**INTEROFFICE MEMORANDUM  
REGULATORY COMPLIANCE  
POTENTIALLY REPORTABLE OCCURRENCE REPORT**

**TO:** MIKE DESILETS, TECHNICAL SUPPORT MANAGER  
**FROM:** JIM DEVINCENTIS, MANAGER LICENSING *JM Devincenis*  
**SUBJECT:** CR-VTY-2004-0981 A PIECE OF SHOOT-OUT STEEL NOT INSTALLED  
**DATE:** APRIL 19, 2004  
**PRO NUMBER:** PRO-040981

Figure 1-5. Lower Control Rod Drive Housing

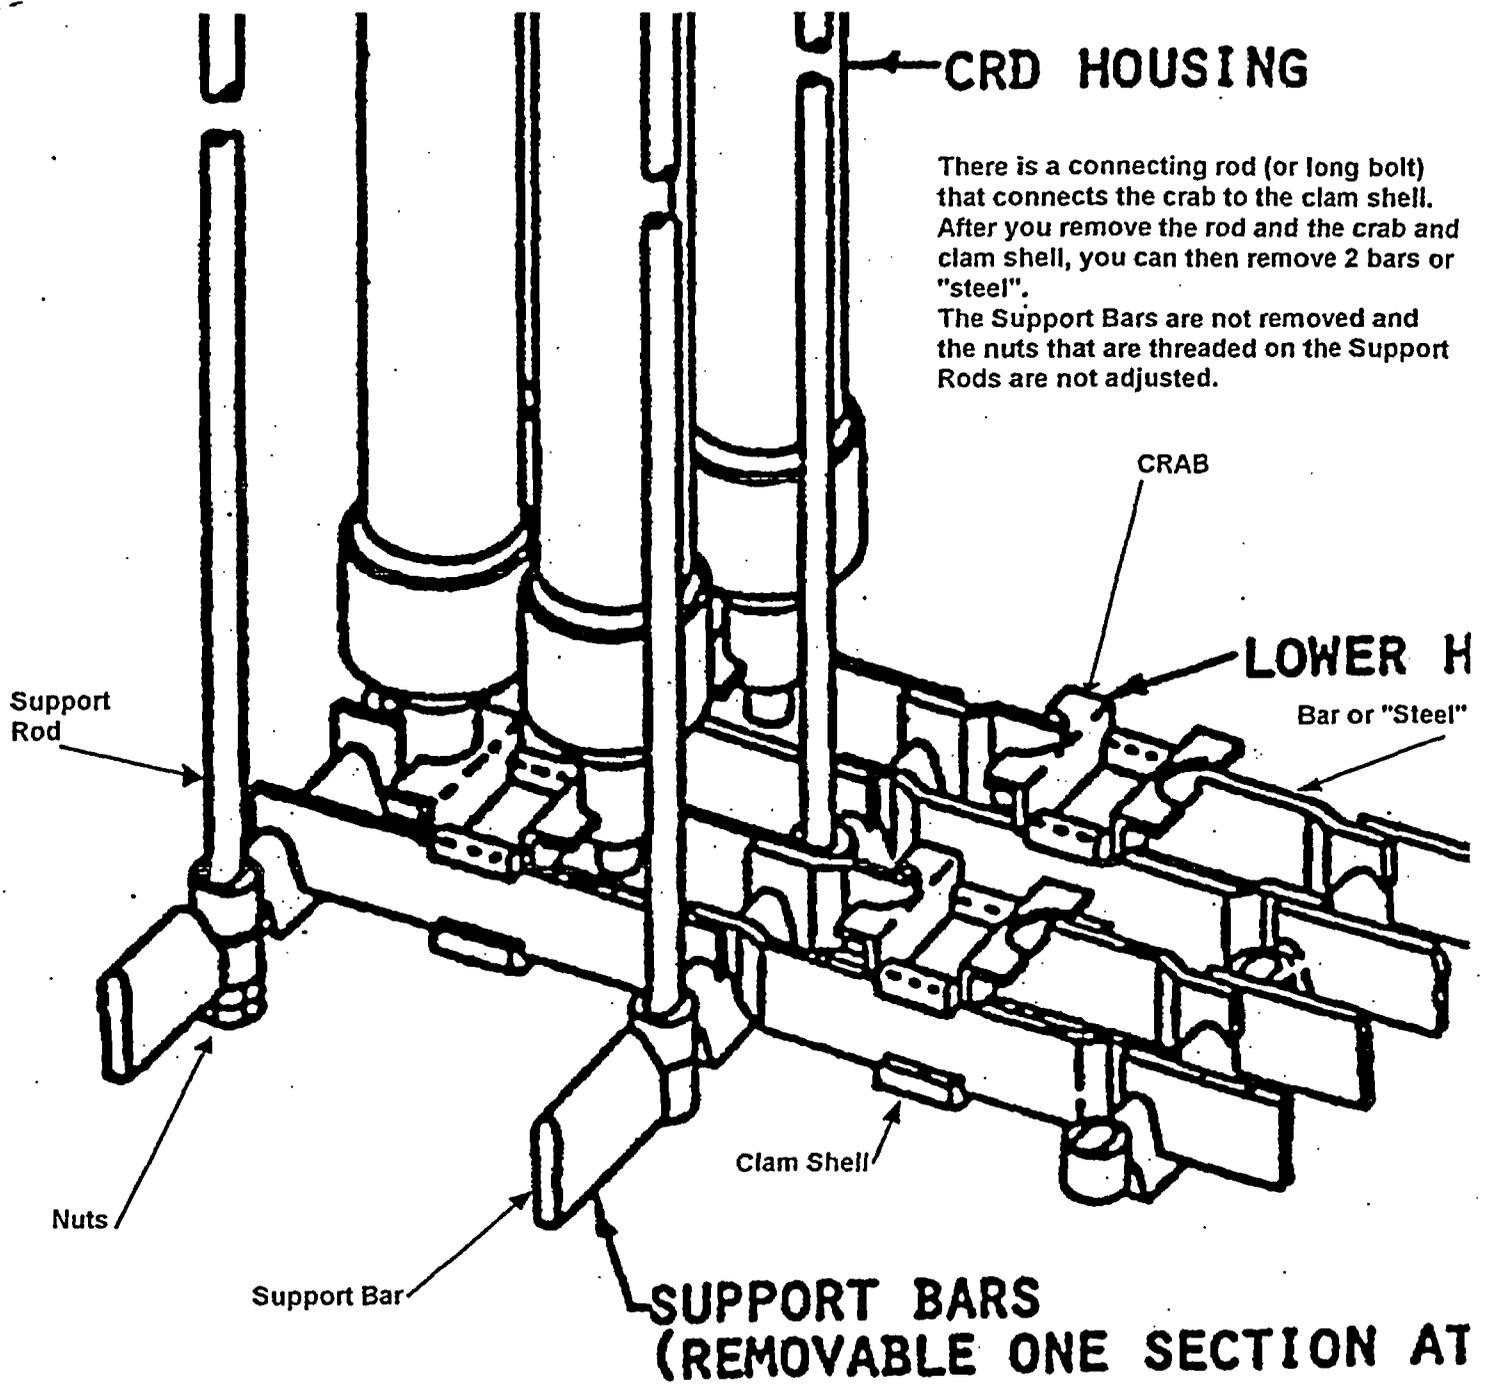
See enclosed figure depicting configuration. The shootout steel is a latticed assembly supported by rods that have incorporated stacked disc springs into them. The assembly functions to resist the downward loads generated as a result of a postulated full circumferential break of a CRD Housing at full power operations. The Clamshell is centered beneath the Crab on the short Steel Bars that run between the Support Bars and Rods. The Clamshell includes a single bolt that protrudes through it from the underside and engages the Crab. Both the Clamshell and the Crab are configured with a notch, or recess, to fit snug across adjacent pieces of the Steel Bars to align the shootout steel as a lattice and to vertically align the CRD Housings. Based on the input received from Jon, the Clamshell was missing but the Crab was in place, engaged across the adjacent Steel Bars and performing its alignment function for the lattice assembly and CRD Housing positioning. Since the forces resultant of a postulated rupture of a CRD Housing are transferred directly to the structural framing (Steel bars, Support bars and Rods) making up the lattice/rod assembly and since that load transfer is not affected with the Clamshell alone being found missing, the prior function of the shootout steel remains assured.

Jon has discussed his intent for obtaining a replacement Clamshell and has initiated discussion with Procurement to buy or fabricate a replacement piece to re-install where the missing one was found.
